## Eberspaecher Parking Expansion JSP13-60

Consideration of the request of Eberspaecher North America, for Preliminary Site Plan and Stormwater Management Plan approval. The subject property is located in Section 22 at 43700 Gen Mar in the I-1, Light Industrial District. The subject property is 8.66 acres and the applicant is proposing to add parking to the site to accommodate an additional working shift as well as an outdoor storage tank.

## PLANNING REVIEW

**SUBJECT: Eberspaecher Parking Lot Expansion, JSP13-0060,  
Traffic Review of Preliminary Site Plan, PSP13-0129**

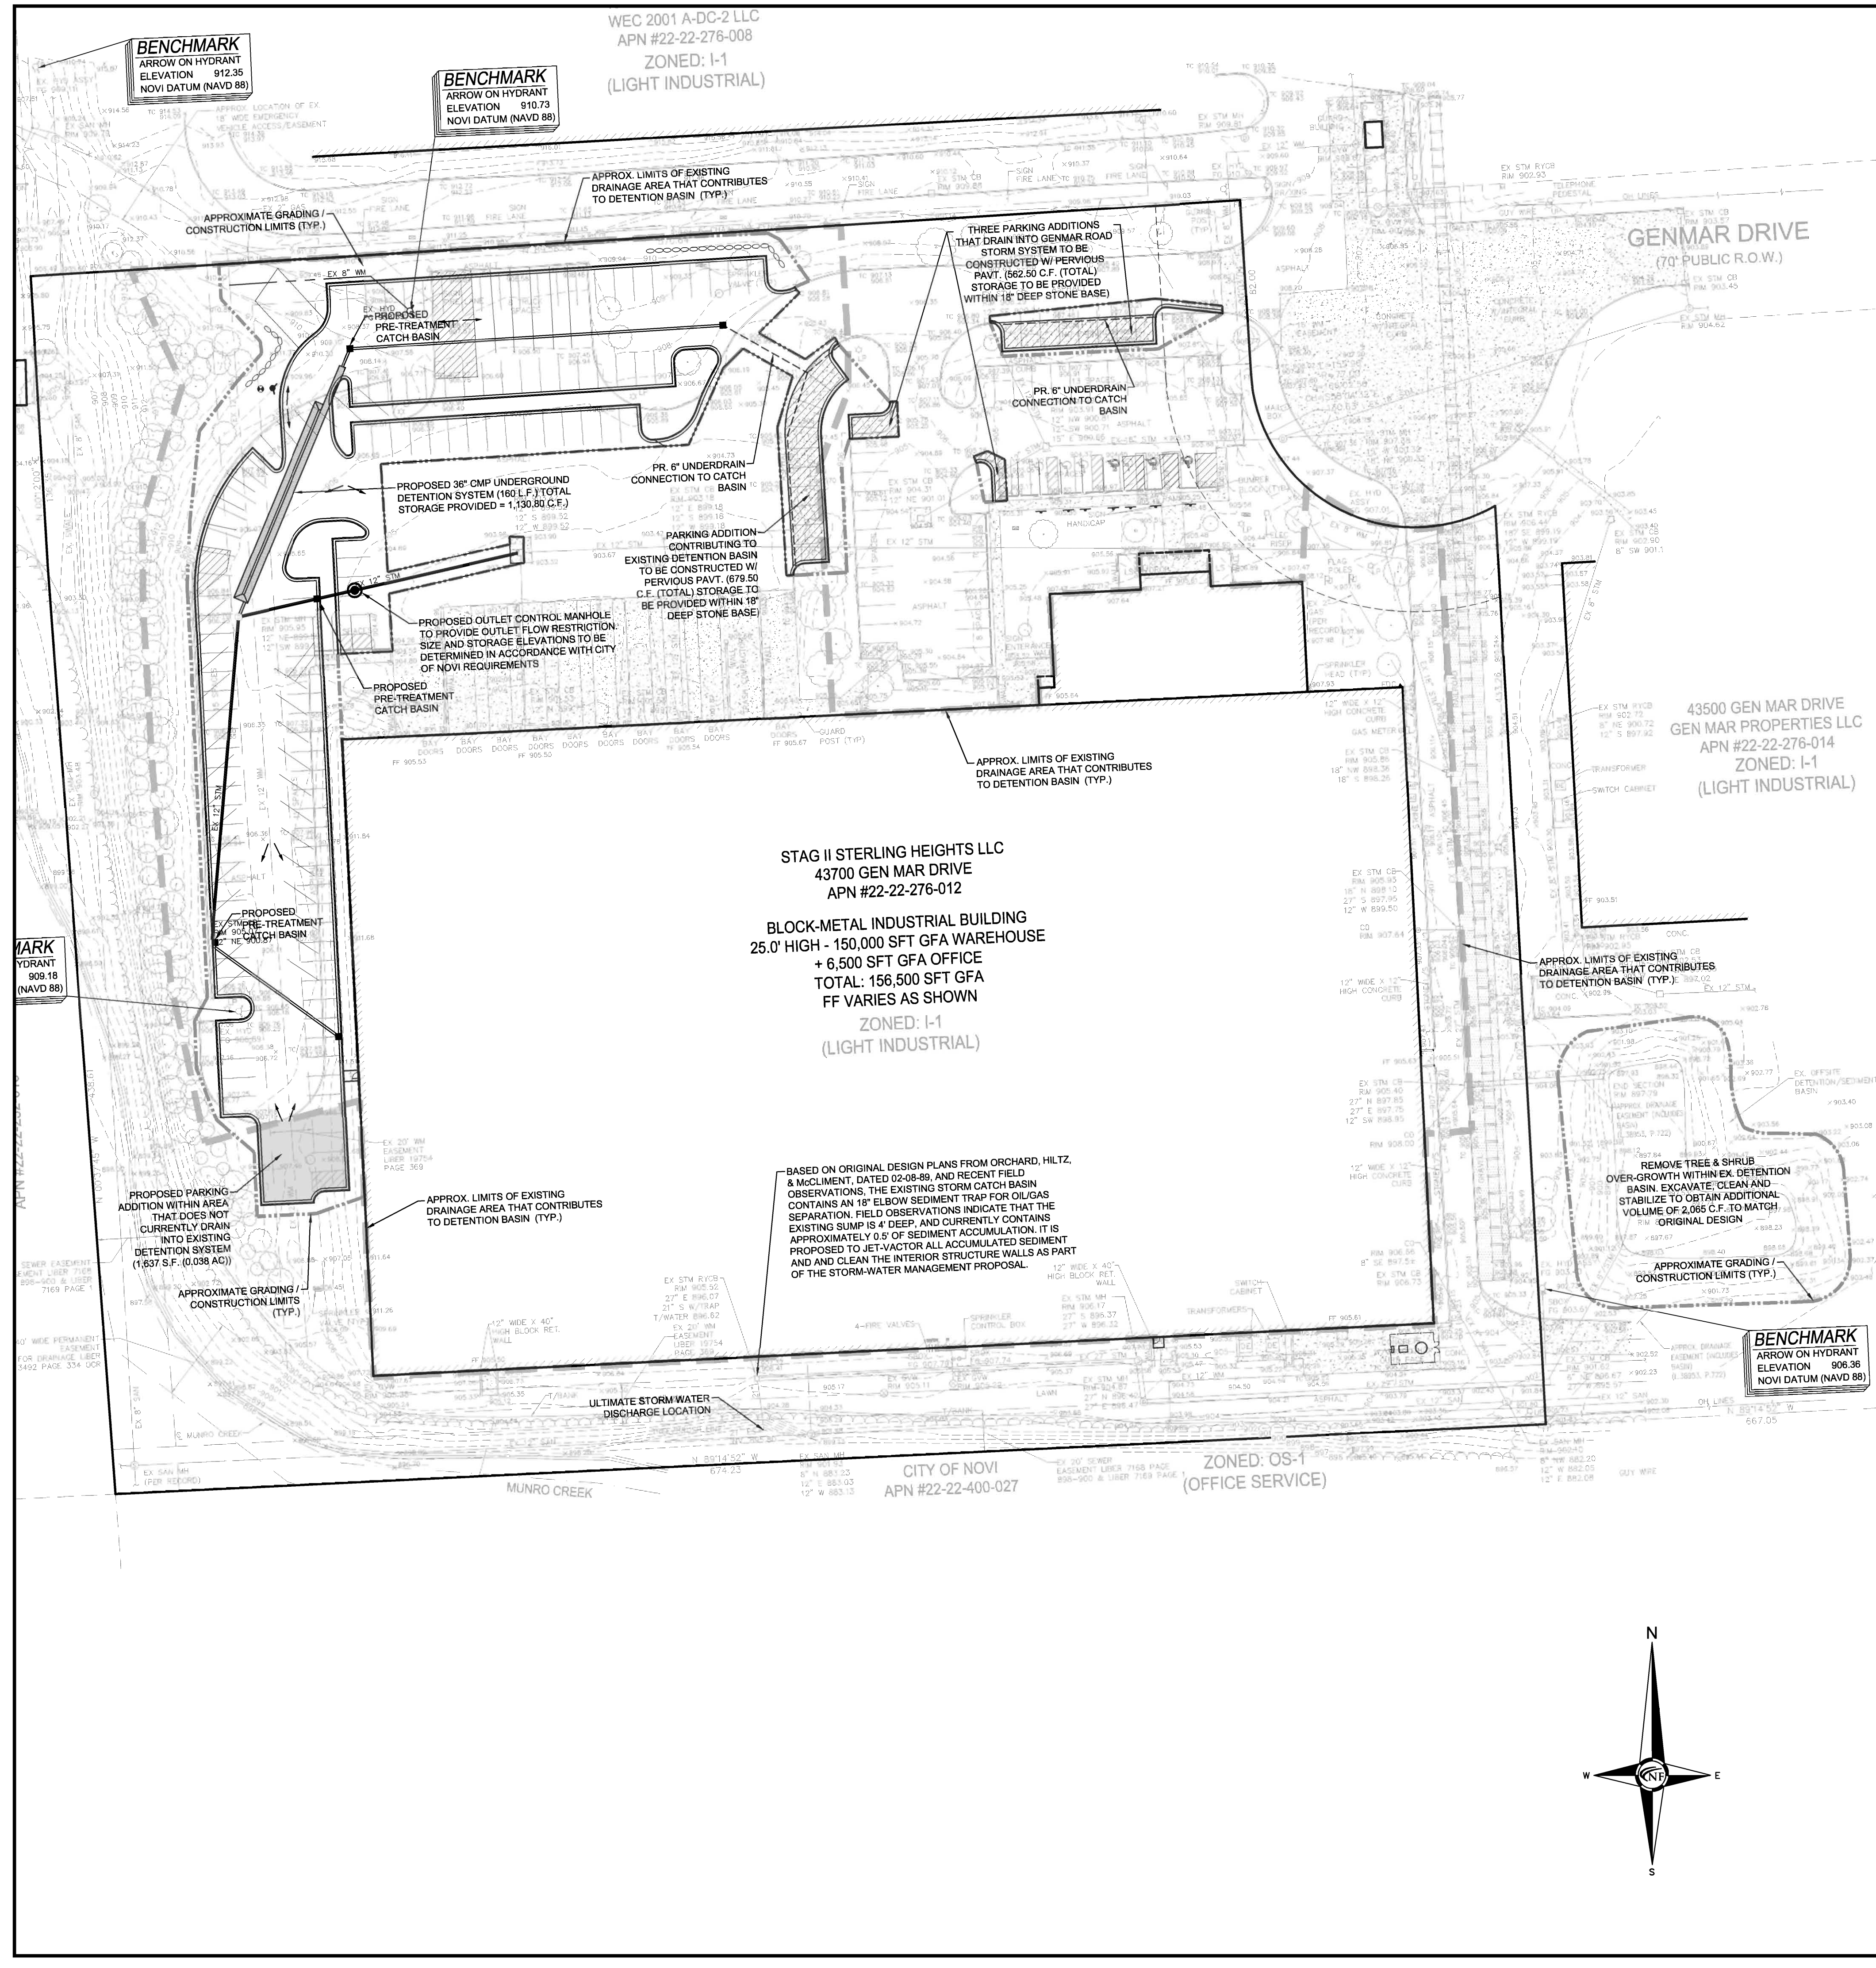
8. Revise the pre-treatment structure configuration to provide an off-line mechanical pretreatment system prior to discharge into the underground detention basin; in-line pretreatment is not allowed.

9. Remove the mechanical pretreatment structures from catch basins 4 and 6. These structures are not needed because the proposed storm sewer discharges into an existing wet detention basin to the east of the development.

10. The proposed pretreatment device Contech model CDS2015-4 is not approved by the City for use prior to discharge into an underground detention system. The only pretreatment device models accepted are Vortechs and Aquaswirl. Revise the plan to provide a pretreatment structure that has been accepted by the City.

12. Revise the storm water detention calculations to demonstrate that bankfull volumes shall be retained in the detention facility for a minimum of 24 hours and no more than 40 hours.

15. Provide a construction detail for the connection between the proposed underground detention basin and the storm sewer network.
16. Provide critical elevations (bankfull and 100-year storm hydraulic grade lines) on the underground detention system cross-section and storm sewer profile demonstrating that the detention system is 3 feet above ground water and has the required 1 foot of freeboard between the high water elevation and the subgrade below the pavement.

Plan View  
Scale 1" = 30'

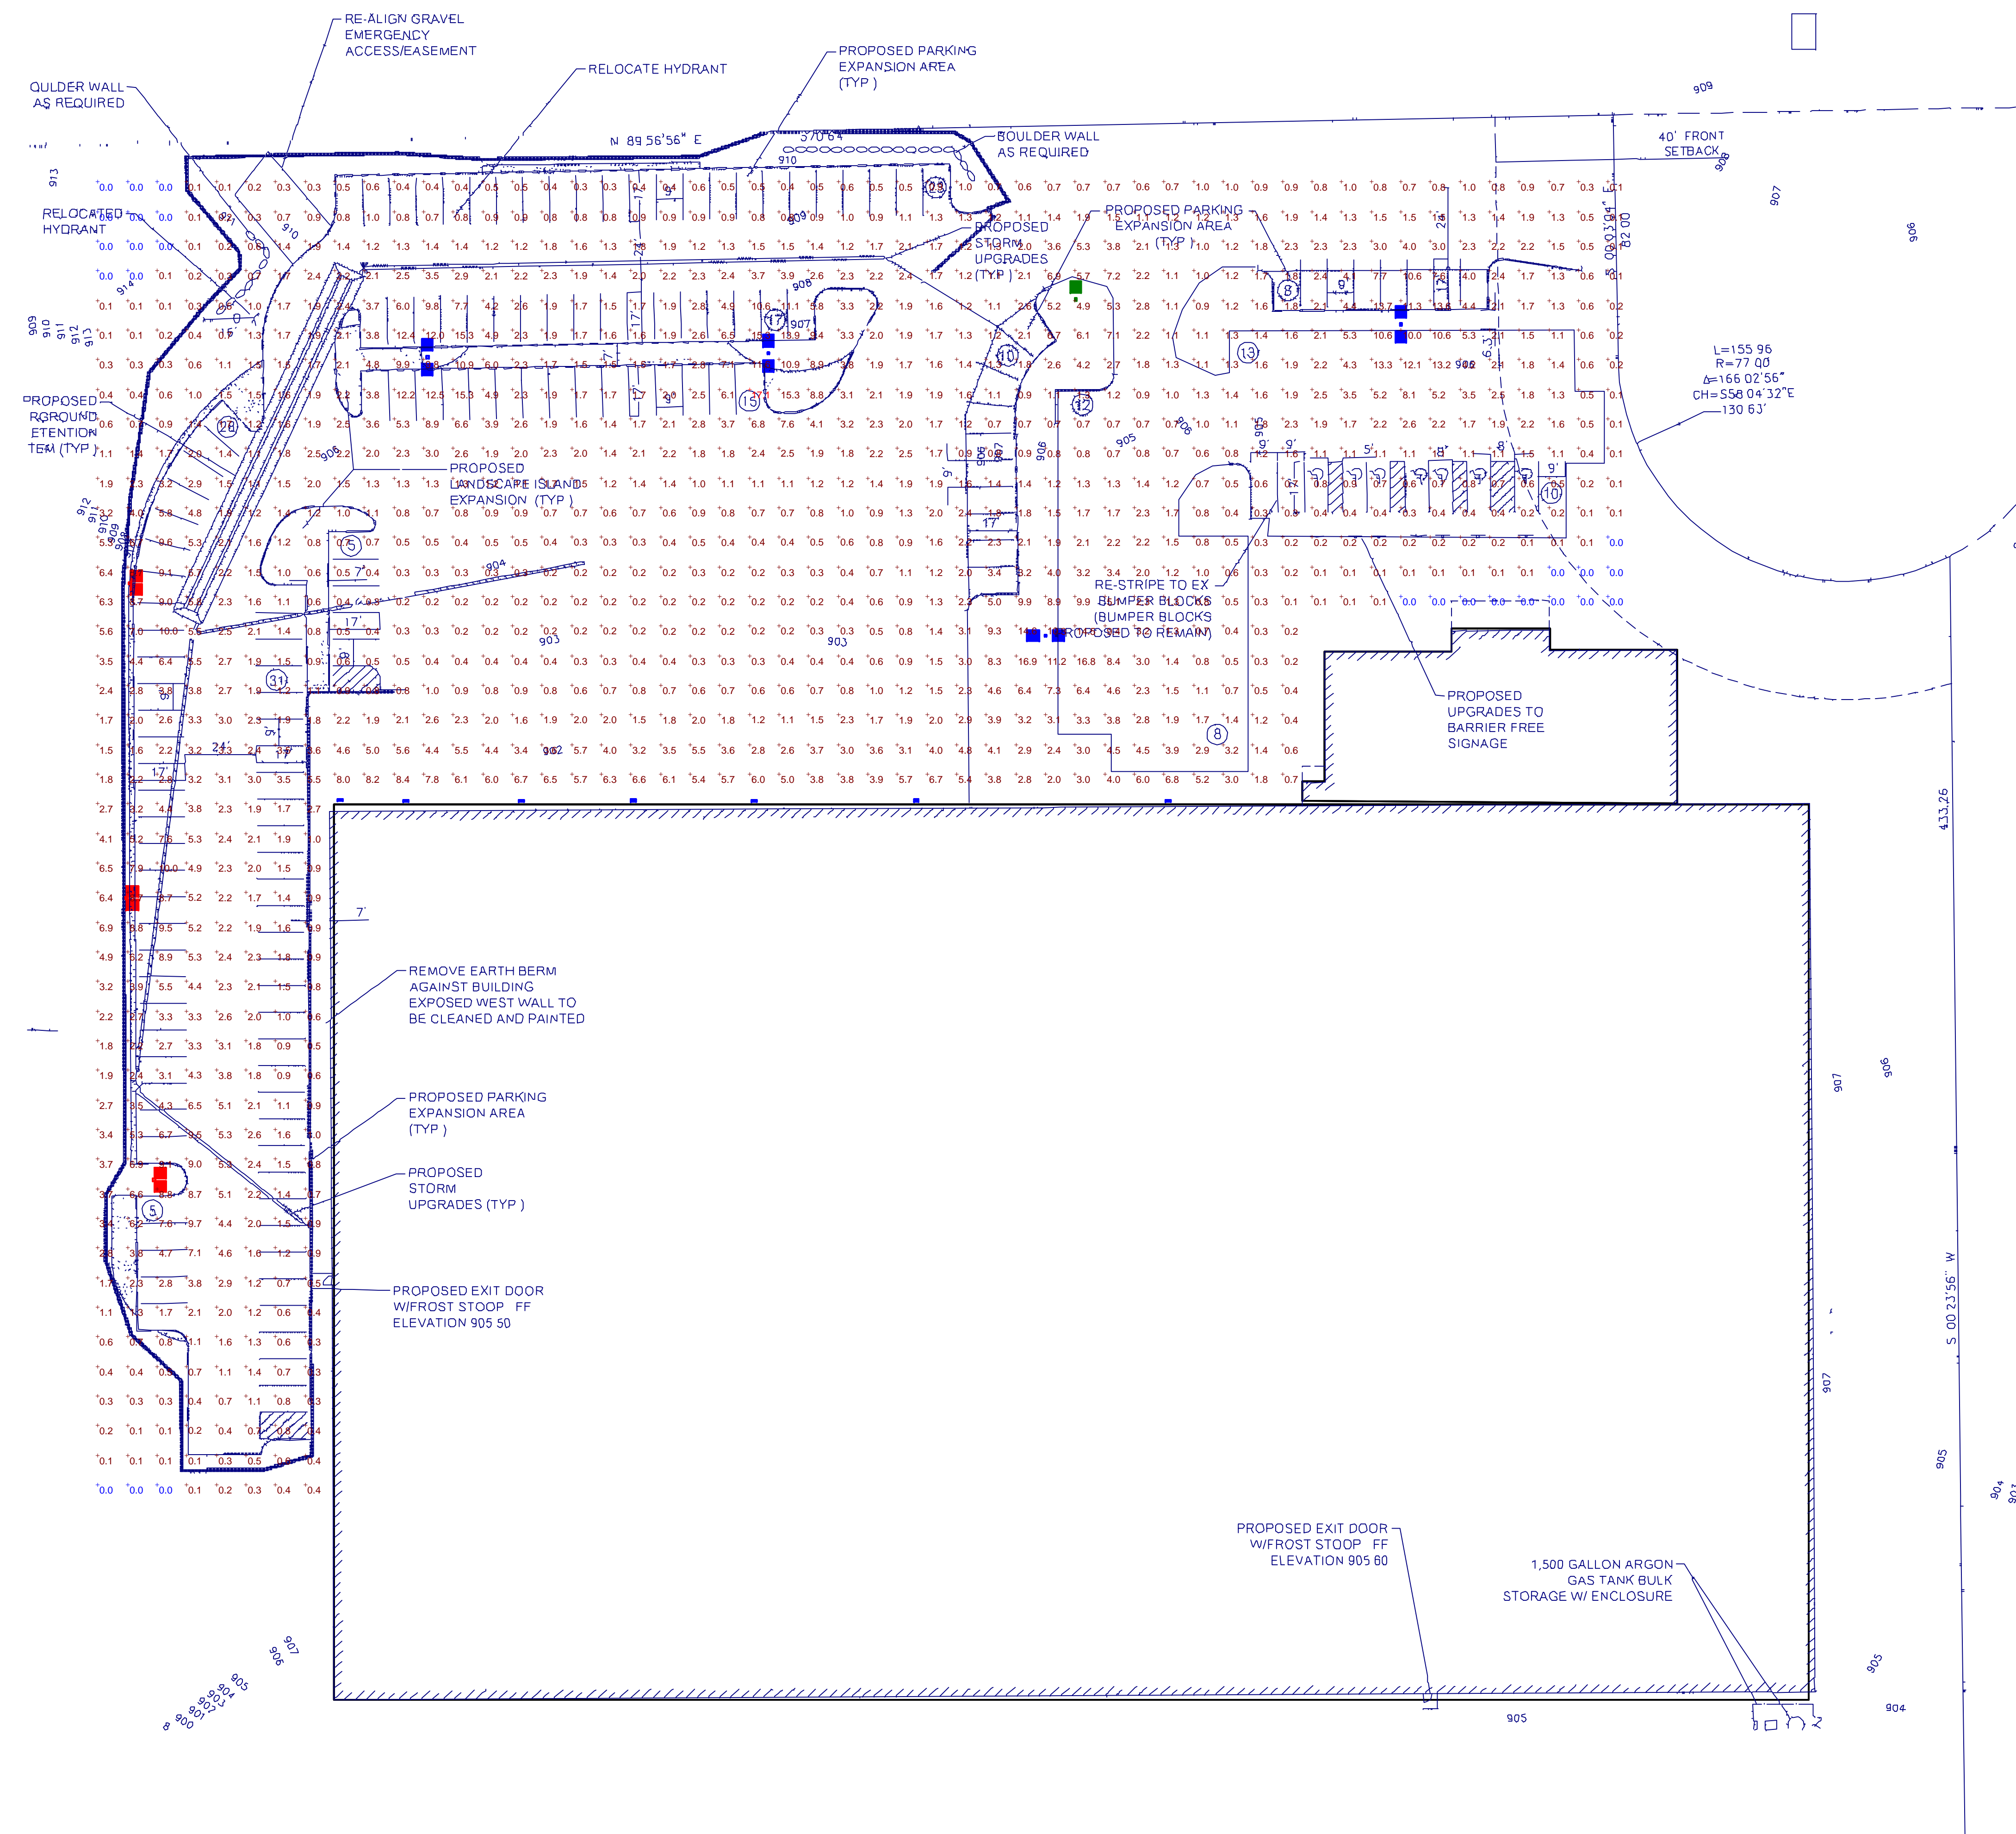
5. Photometric Plan: There are several deficiencies identified for the photometric plan in the lighting review chart. **The applicant must provide the manufacturer's specifications for all proposed lighting fixtures and provide the required information on the photometric plan.**

Maximum Illumination adjacent to Non-Residential (Section 2511.3.k)	When site abuts a residential district, maximum illumination at the property line shall not exceed 0.5 foot candles	Yes?	Light levels at the property line must be provided. The western property line is especially important.
Cut off Angles (Section 2511.3.1(2))	All cut off angles of fixtures must be 90 degrees when adjacent to residential districts	Yes?	Applicant should provide manufacturer's specifications for all proposed fixtures.

1. The manufacturers specifications and hours of operation for all proposed lighting fixtures will be provided on the updated photometric plan that will be submitted with the final site plan drawings.

2. The proposed fixtures will be 25 feet in height. A note stating the fixture height will be included on the updated photometric plan that will be submitted with the final site plan drawings.

5. The requested light levels at the property line will be provided on the updated photometric plan that will be submitted with the final site plan drawings.
